**Addendum No. 1 to the**  
**Environmental Impact Assessment**  
**(January 2016 version)**  
**For the**  
**Dhaka Mass Rapid Transit Development Project**

**By NKDM**

**July 2016**

- Figure 3-7 is replaced with the following: (this changes the rail section from UIC54 to 60E1)

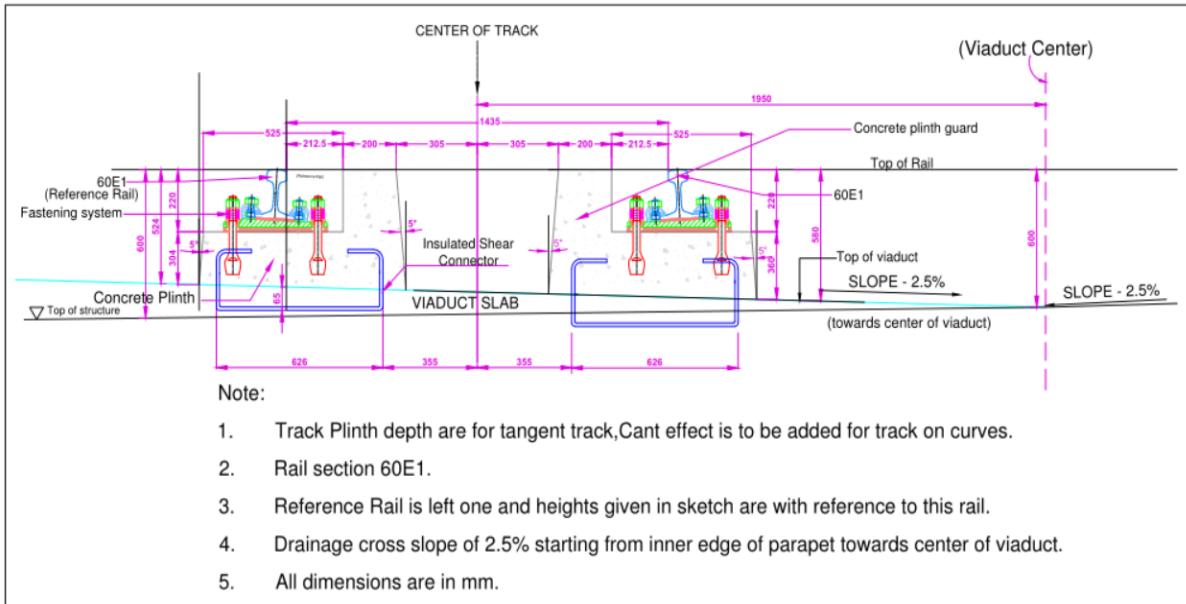
Consequence: Flattening of curvature results in a reduction in noise; otherwise the revision involves a clarification of terms (e.g. FST in place of MSS) and of fact (use of lubrication on outer rail gauge).

## 3. Chapter 3, Sec. 3.3.3: Stations (Figures 3-9 – 3-11, architectural renderings of station exterior, interior and entry/exit facilities)

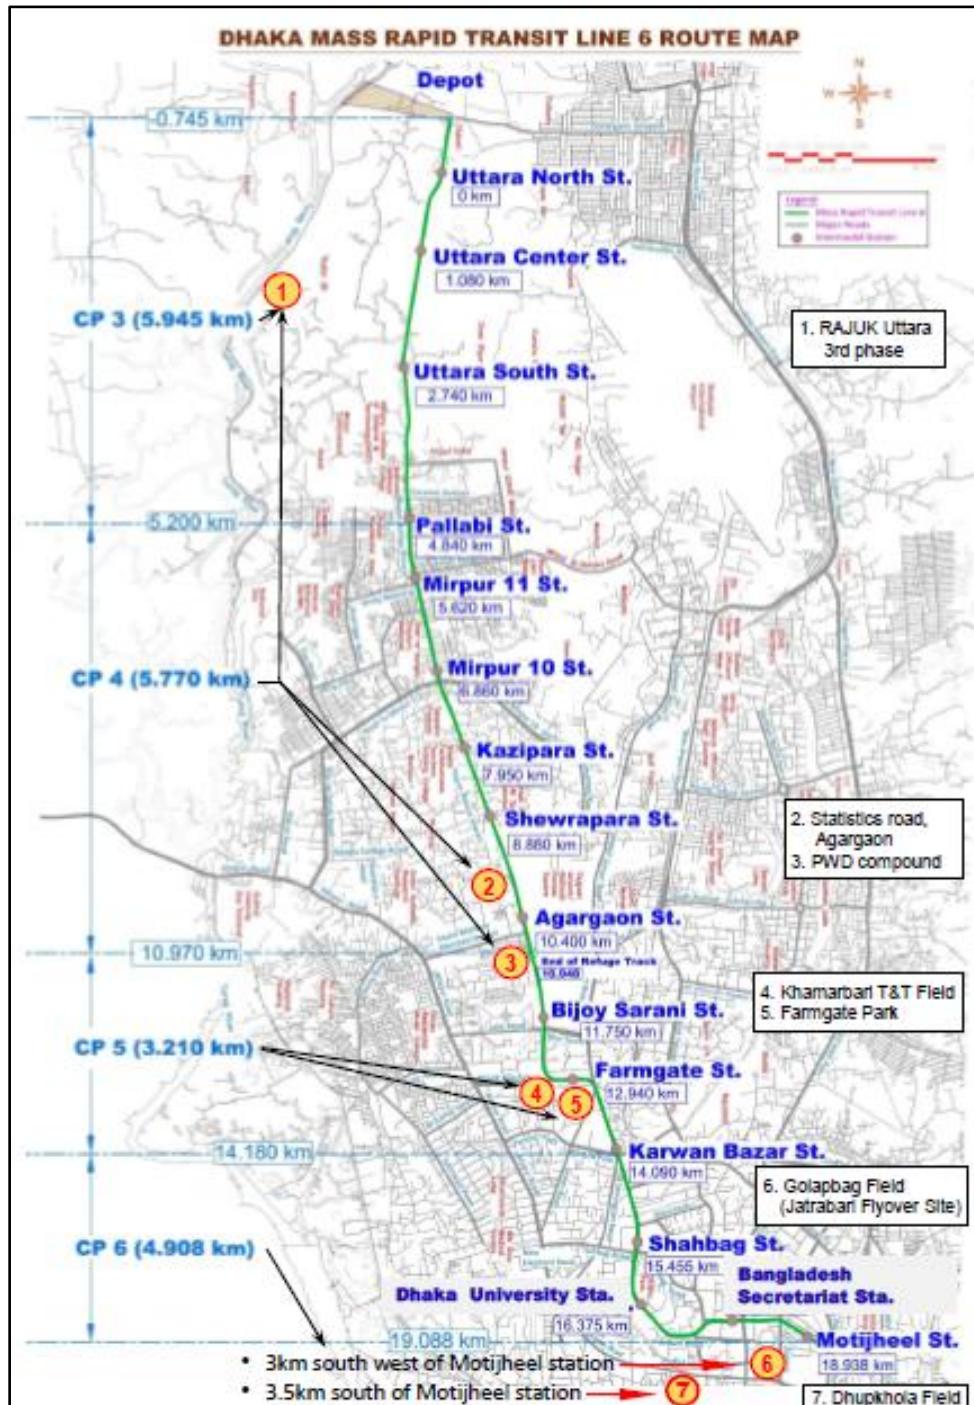
The roof line is being revised and these figures will be replaced; however the design has not been finalized and replacement figures are not yet complete. Architectural drawings will be provided in a future addendum once available.

Replace Figure 3-12 with the following:

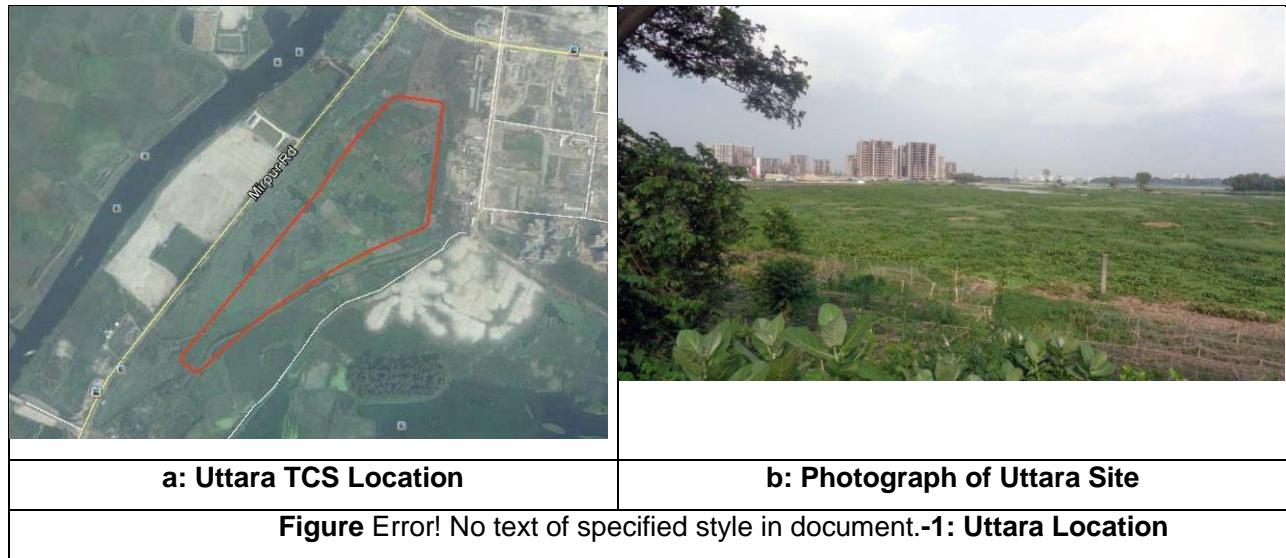
"Eight locations have been identified for temporary construction facilities for use under contracts CP-3 – CP-6 (see the next section). Seven of these sites are confirmed, whereas the eighth site (Rayer Bazaar) is still under discussion. The seven confirmed sites are shown in Figure 3-12. Environmental aspects of these sites are evaluated in Chapter 6."
